Response to Comments Received By Tulare County

Delano-Earlimart Irrigation District Groundwater Sustainability Agency

Delano-Earlimart Draft GSP - summary of County notes – responses to County notes

Subject: Comments on the Delano-Earlimart Subbasin Groundwater Sustainability Plan

Figure 4-3 from the DEIDGSA GSP

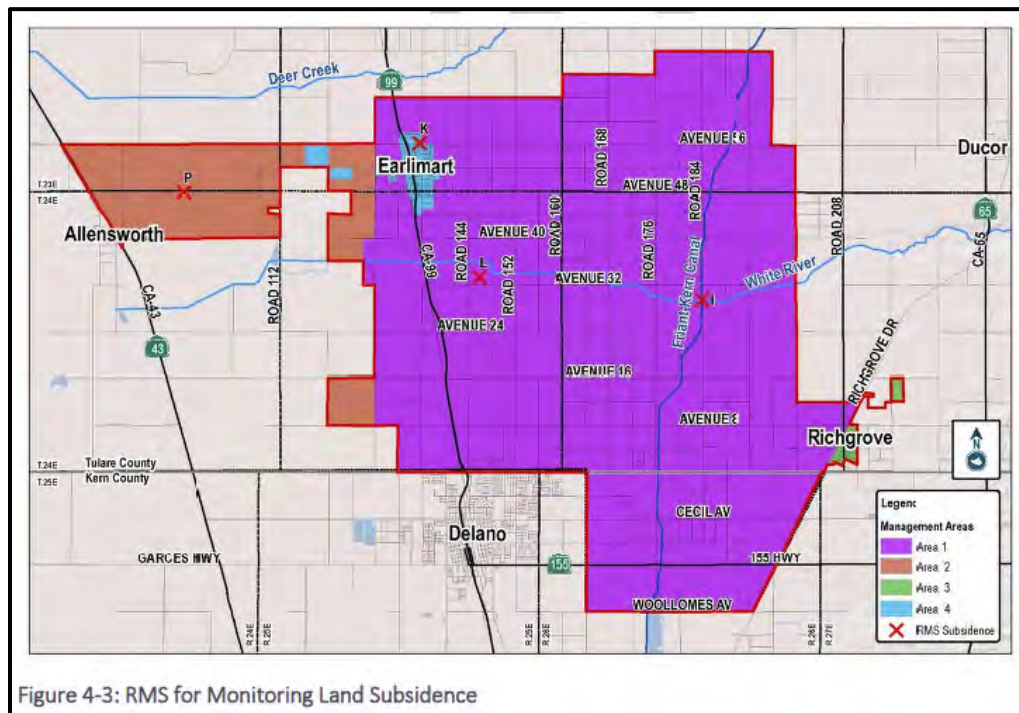
The Tule Subbasin contains a “land subsidence monitoring area” that is approximately centered around the FKC and extends west four miles and eastward to the 1-ft cumulative subsidence 1986-2017 contour. This area is shown by the solid pink line in Figure A1-8 of Attachment 1 of the TSCA (see figure below). This map figure also shows the cumulative subsidence between 2015 and 2018 based on InSAR data. Based on this data, the subsidence along the FKC during this period was up to 1.25 ft.

The ETGSA contains a “Friant-Kern Canal Subsidence Management Area” which appears to be the same as the “land subsidence monitoring area” mentioned in the TSCA Monitoring Plan.

Comment: The Monitoring Network for subsidence in the vicinity of the FKC is inadequate.

Figure 1. Potential GDEs identified in the State Board Staff Report and sites evaluated by DEID GSA

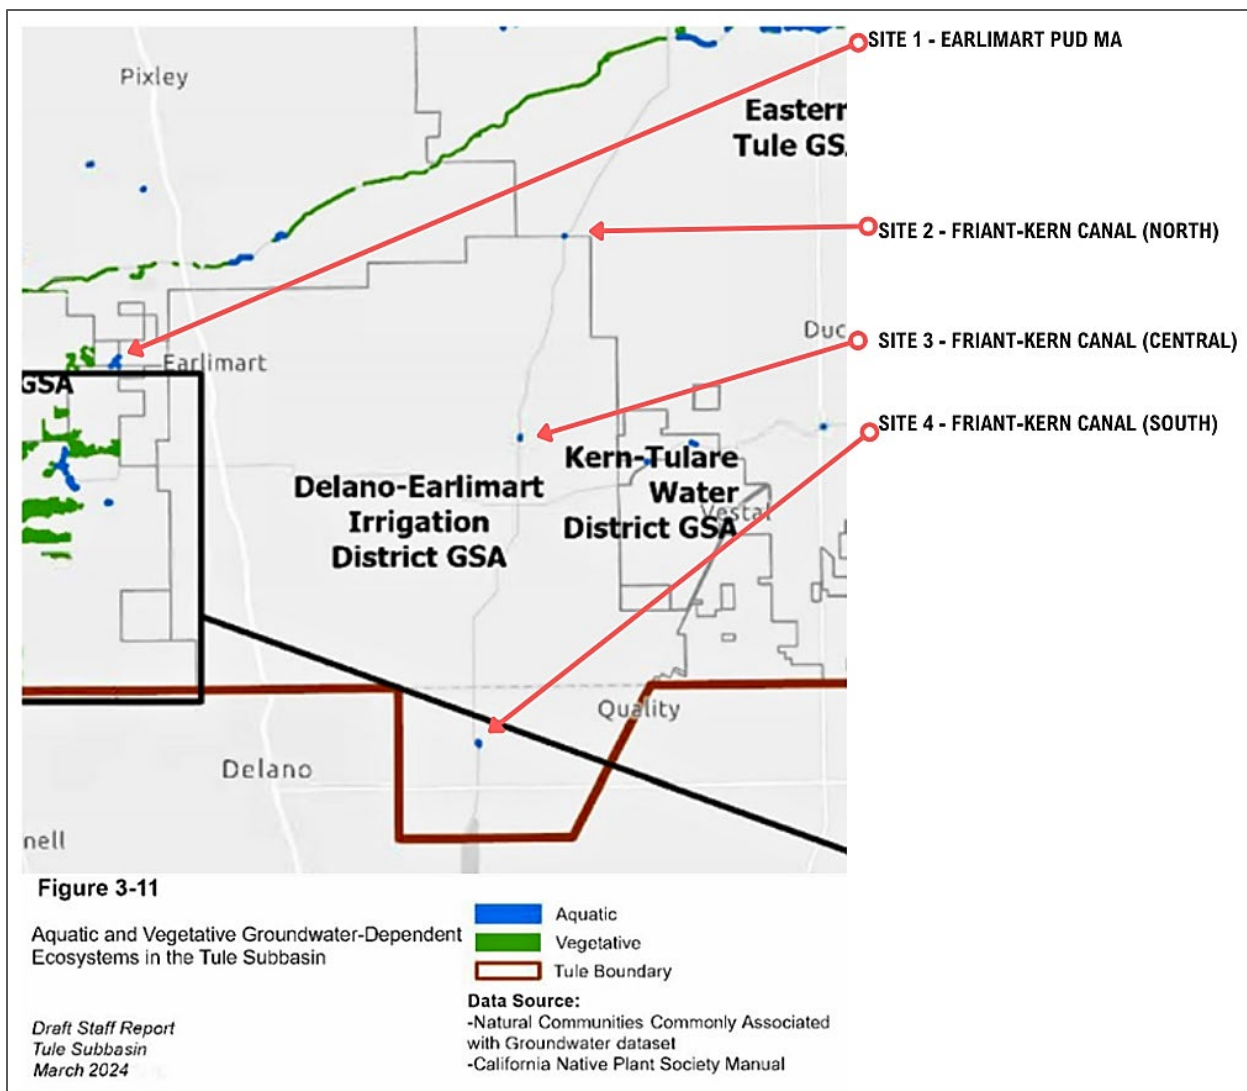
Draft Staff Report Figure 3-11, which depicts the State Board staff's evaluation of potential GDEs within the DEID GSA sourced by the Natural Communities Commonly Associated with Groundwater (NCCAG) Dataset Viewer (Klausmeyer et al, 2018) and California Native Plant Society Manual (Sawyer et al, 2009) identified four potential GDEs Sites 1 through 4 in the DEID GSA (**Figure 1**).

- (1) Aerial imagery during the historically wet 2023 conditions were reviewed to assess the presence of potential GDEs at sites identified as potential GDEs by the NCCAG dataset and California Native Plant Society Manual and reported by the State Water Resources Control Board (SWRCB). Each identified potential GDEs within DEID GSA shown in Figure 1 was assigned a site-identification (Sites No. 1 – No. 4) which correspond with the aerial imagery described below:

- Site 1 (Earlimart) – This site is in the vicinity of agricultural lands and recharge and wastewater treatment facility retention ponds for the community of Earlimart. It is likely that these retention ponds were mischaracterized as potential GDEs. **Figure 2** is a snapshot of Google Earth in May 2023 of Site 1. The Earlimart Public Utilities District Wastewater Treatment Facility Waste Discharge Requirements (WDR) Order No. 98-140¹ and CEQA documentation for the facility² were reviewed to evaluate the potential for GDEs to occur. WDR Order No. indicates that, “Based on the information obtained from the ‘Lines of Equal Elevation of Water in Wells in Unconfined Aquifer,’ published by Department of Water

Figure 3. Site 2 (FKC North) Source: Google Earth aerial photography from May 2023 (during historic wet year)

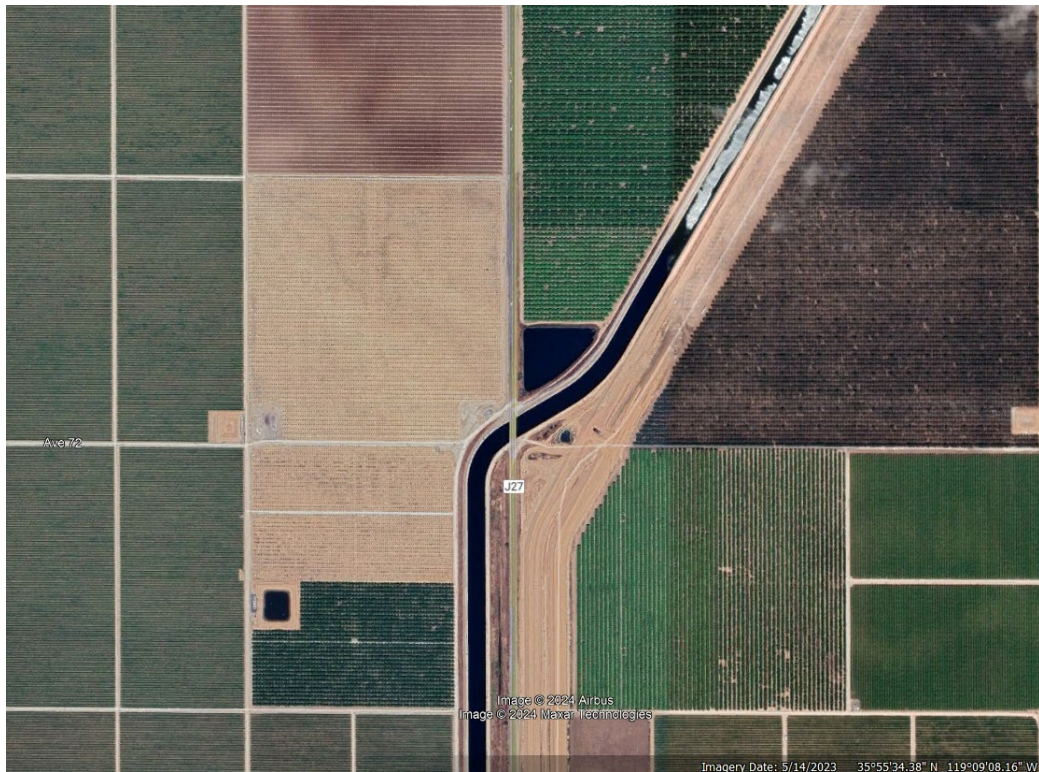
- Sites 2-4 (FKC North, Central, South) – These sites are located within and/or adjacent to the Friant-Kern Canal (FKC), which is a concrete lined system and disconnected from groundwater. It is likely that the NCCAG dataset and California Native Plant Society Manual sources mischaracterized these portions of the FKC as being aquatic ecosystems. Figure 3, Figure 4, and Figure 5 are snapshots from Google Earth in May 2023, in which groundwater levels were at or near their peak in the historic wet year³.

Figure 7. 2023 Water year seasonal high (spring 2023) upper aquifer groundwater level contours for the DEID GSA plan area

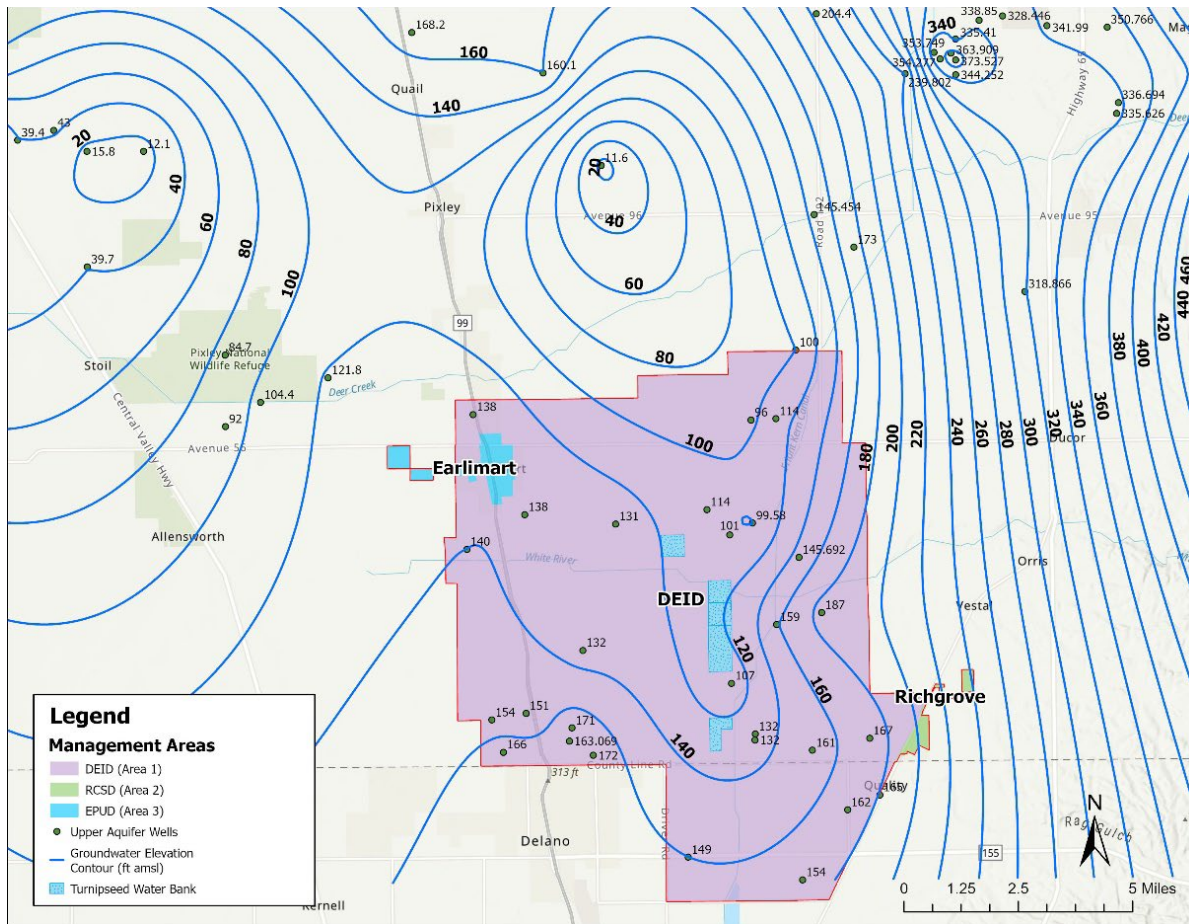
Resources in Spring 1996, the depth of groundwater in the region is 100 feet below ground surface”. As shown on **Figure 7**, the 2023 upper aquifer groundwater level elevation is 120 to 140 feet (ft) above mean sea level (amsl) or 120 to 140 ft below ground surface (bgs) near the retention ponds and not likely to support the minimum rooting depth of GDEs.
